Bulletin: CLIB-0009

Topic: New Integral Hydraulic Clutch Release Production Release

Issue Description: We are releasing an Integral Hydraulic Clutch system for manual and AutoShift transmissions. This system replaces the currently available multi-piece hydraulic clutch release system for models using the current HD 15 ½" two plate clutches.

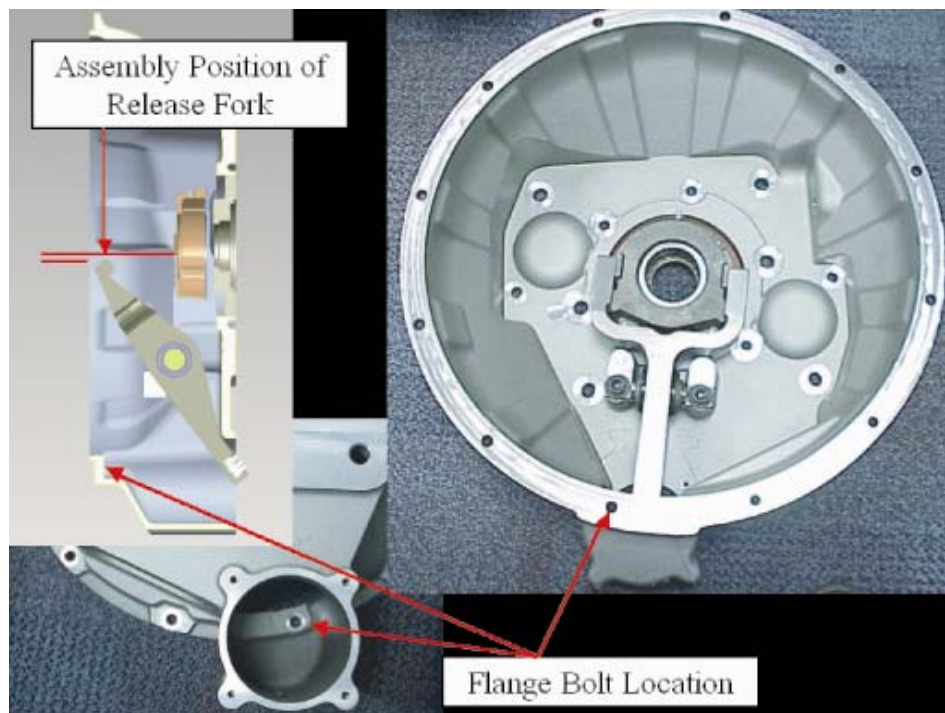
Affected Models/Population: The following matrix explains where the new Integral Hydraulic Clutch Release Housings are available.

Similar to the current design, this system will not accommodate the FR Integral Cooler. Lightning models must continue to use the A-7414 release system.

OTHER REQUIREMENTS

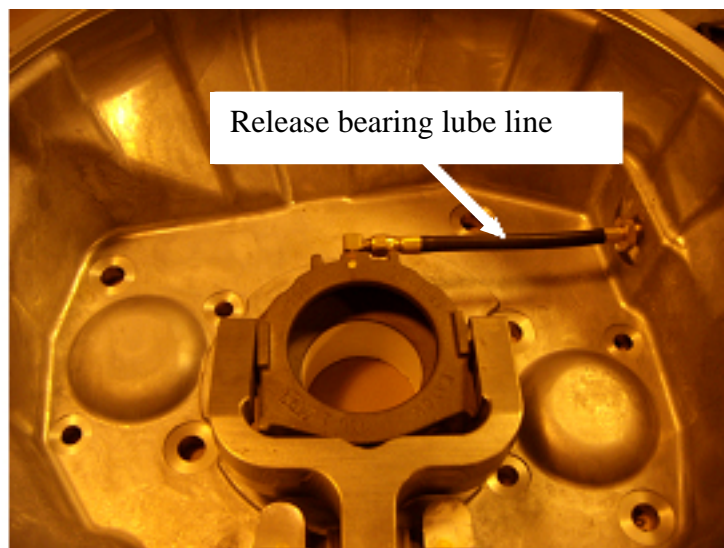
The integral release fork (part number A-7786) will be serviced at the assembly level. If removal is needed the fastener retainer plates (part number 4306015) and Release fork bolts (part number X-7C-1201M) must be replaced after each removal of the release yoke. Release fork bolts must be torqued to 106 -114 lb. ft.
